Technical Report			
Application No:	PA20/481		
Lodgement Date:	11 June 2020	DAU Date:	
Address:	32 Paterson Street, Mundijong		
Proposal:	Drivethrough Bottle Shop		
Land Use:	See report	Permissibility:	See report
Owner:	CC Wormal Pty Ltd		
Applicant:	Harvey Construction WA		
Zoning:	Urban Development	Density Code:	N/A
Delegation Type:	12.1.1	Officer:	Haydn Ruse
Site Inspection:	Yes		
Advertising:	Yes		
Outstanding Internal Referrals:	No		
External Referrals:	Yes		
Department of Planning, Lands and Heritage			
Within a Bushfire Prone Area:	Yes

A planning application dated 11 June 2020 has been received for proposed Drive through Bottle Shop at 32 Paterson Street, Mundijong.

Turning Templates

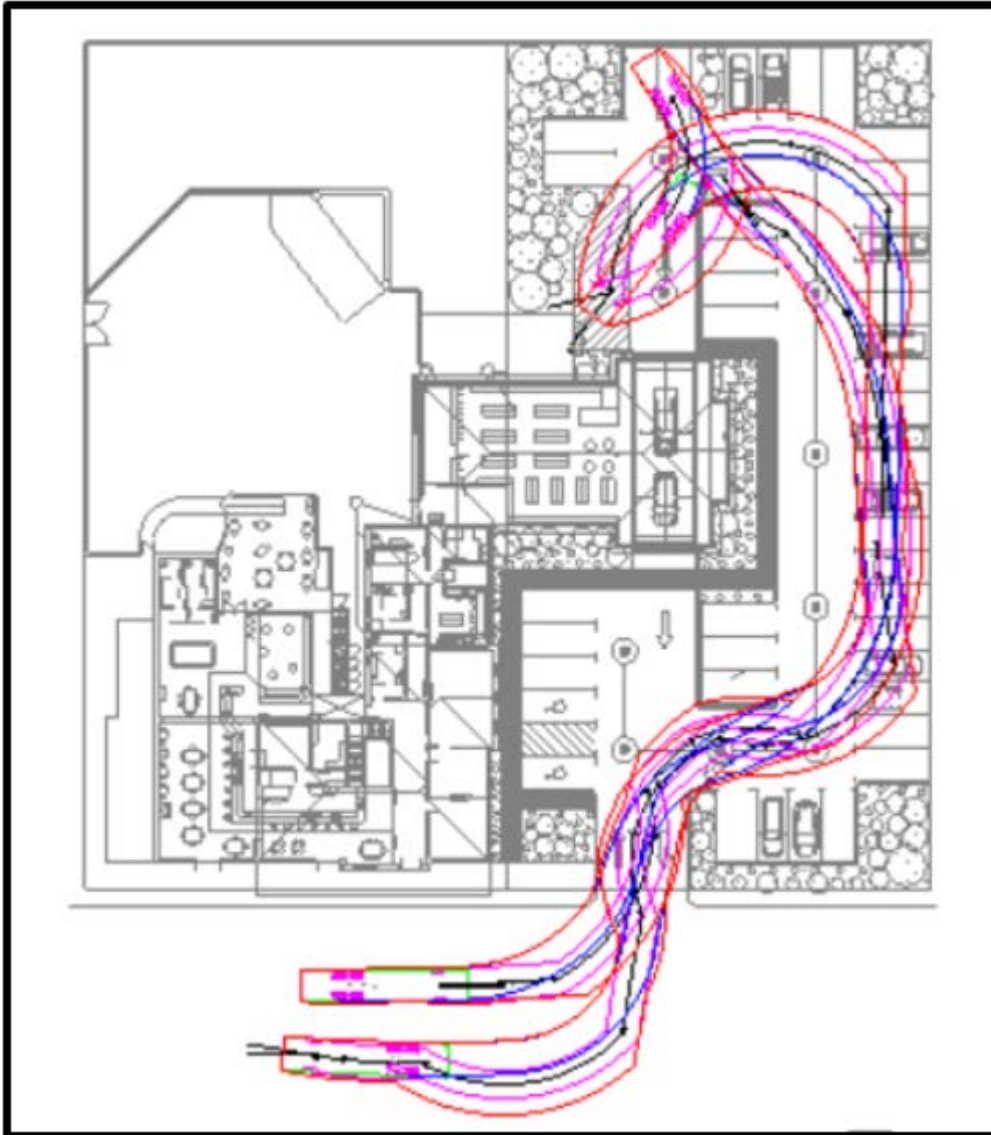
The TIS also highlights a fairly complex internal maneuvering arrangement for servicing vehicles, which could only be undertaken at times when the car parking area is almost entirely empty, as shown following. There is no option to move the access further north on the site due to the existence of a bus shelter and street lighting infrastructure.

There is the option of restricting loading and unloading times to times where the car park will most likely be empty, which is considered a relevant and incidental component of the development that can be conditioned. Through limiting loading/unloading times to outside peak utilization times (deemed 11am to 7pm daily), the proposed configuration of development can be supported.

This support however is conditional upon plans and specifications being submitted and approved by the Shire, and particularly through this process consider incidental elements like curbing design, drainage location, landscaping types such that the safe maneuverability of loading and unloading can be achieved.

Shared Access Arrangements -LPP 3.4 Paterson Street Design Guidelines

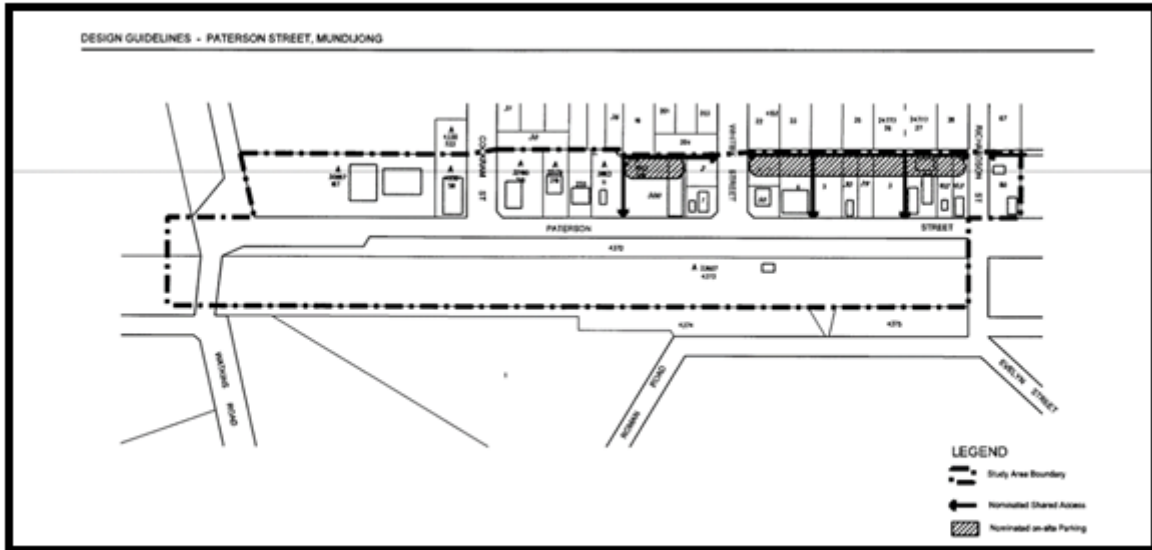
LPP 3.4 envisages that the rear laneway that adjoins the development will be fully constructed in the future, to cater for two way vehicle movements. This would require a 10 m laneway width being constructed in the future, compared to the current 5m width. Officers recommend imposition of a condition that requires 2.5 metres of land

across the full length of the subject site, which is both Lot 6 (32) Paterson Street and Lot 5 (34) Paterson Mundijong. These two lots combine to represent the ultimate development site, with a condition imposed that requires amalgamation prior to issue of a Building Permit.
